17 December 2014

the architectural centre inc.
PO Box 24178 Wellington

re: Traffic Resolution - Island Bay

Fig 1: Accidents (2000-2014) for Adelaide Rd (red) and The Parade (black)

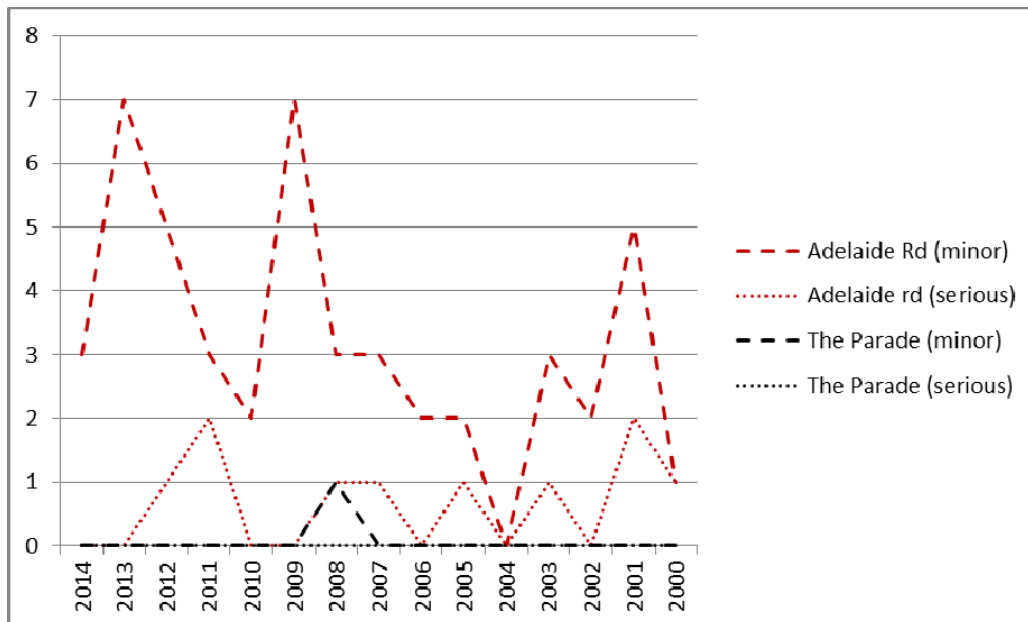
In this regard we also note the very low accident numbers involving cyclists on The Parade over the period 2000-2014, and query whether Island Bay (and The Parade) has the greatest need for cycling infrastructure in Wellington city. The following graphs compare The Parade and Adelaide Rd accidents and injuries (data is taken from NZTA Crash data).

There have been only three cycling crashes on The Parade since 2000 (2008: Dee St (at 5.05pm), and Medway St (at 3.26pm); 2003: Avon St (at 6.35pm)); two with no injuries, one with minor injuries. The graphs indicate a greater need for cycling infrastructure in Adelaide Rd (59 crashes involving cyclists since 2000; 10 serious, 48 minor, 1 with no injuries), suggesting that The Parade is a much safer cycling environment than Adelaide Rd, which may be due to lower traffic levels, or other reasons.
